REMARKS

AMENDMENTS TO THE DRAWINGS

The attached sheets of drawings include changes to Figures 20 and 21. The attached sheets, which includes Figures 19-23, replace the original sheets including Figures 19-23.

Fig-20

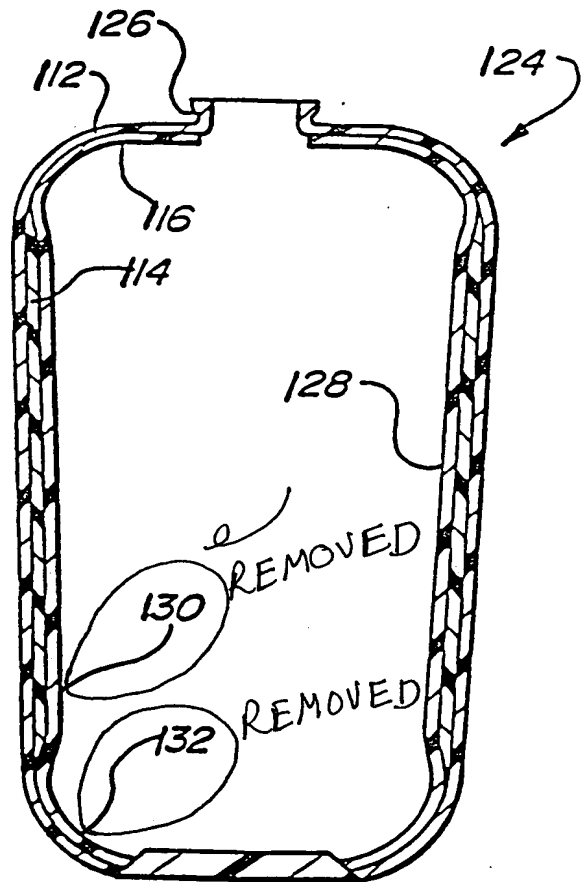
Reference signs 130 and 132 appear in Figure 20 but are not mentioned in the description. Reference sign 170 appears in Figure 21 but is not mentioned in the description. Applicants present replacement figures in which reference signs 130, 132, and 170 have been removed.

A copy of the original sheets highlight the changes in red ink.
